**CASE / FORD NEW HOLLAND – serije 40 i 10**

Br. art. 3482 600 105

Sl. 1: jednostavna spojka s tanjurastom oprugom promjera 330 mm

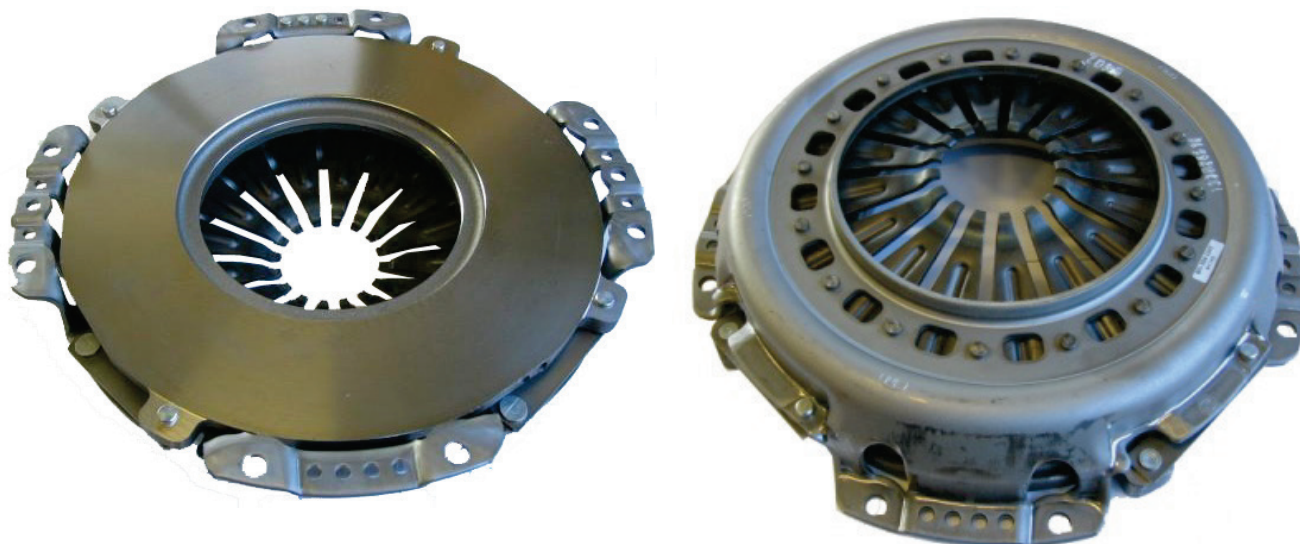
Kada se spojka sa zavojnom torzijskom oprugom i četiri poluge zamjenjuje spojkom s tanjurastom oprugom marke SACHS, podloške nisu potrebne.

Spojka s tanjurastom oprugom marke SACHS smije se ugraditi samo s diskom spojke marke SACHS (vidi tablicu).
